App. No. 10/710,296
Amendment dated November 17, 2005
Reply to Office action of June 28, 2005

Amendments to the Drawings:

REMARKS

FIG. 5A

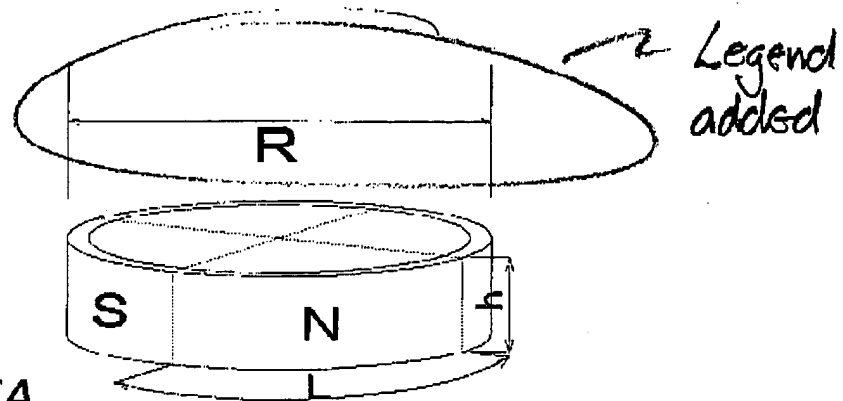
The attached drawing sheets include changes to Figs. 5A and 6-8. The sheet containing Figs. 5A-5D replaces the original sheet containing Figs. 5A-5D, wherein the radius "R" has been indicated in Fig. 5A. The sheets containing Figs. 6-8 respectively replace the original sheets containing Figs. 6-8, wherein the mark "1/Rs" has been added to the legend under the horizontal axis in the graph that each figure presents.

Applicant has amended Fig. 5 to add the mark "R," which is the diameter of the circumferential surface to be magnetized in the case where one of the surfaces is magnetized, or which is the diameter of the outer circumferential surface in the case where both of the inner circumferential surface and the outer circumferential surface are magnetized.

FIG. 6

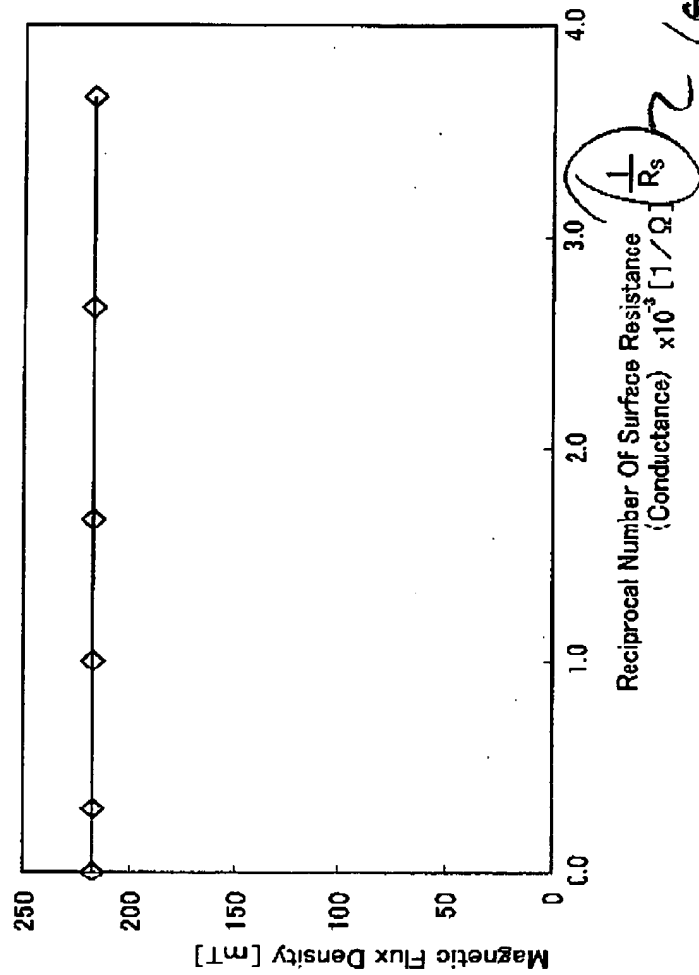
Applicant has also amended Figs. 6-8 to add an indication of "surface resistance Rs."

FIG. 8

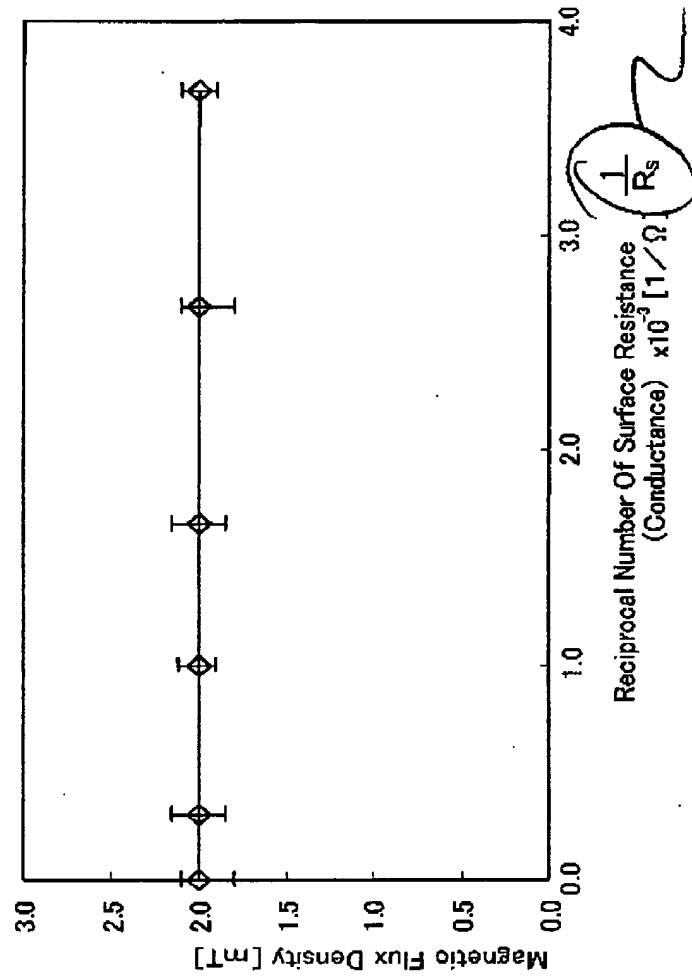
Legend
added
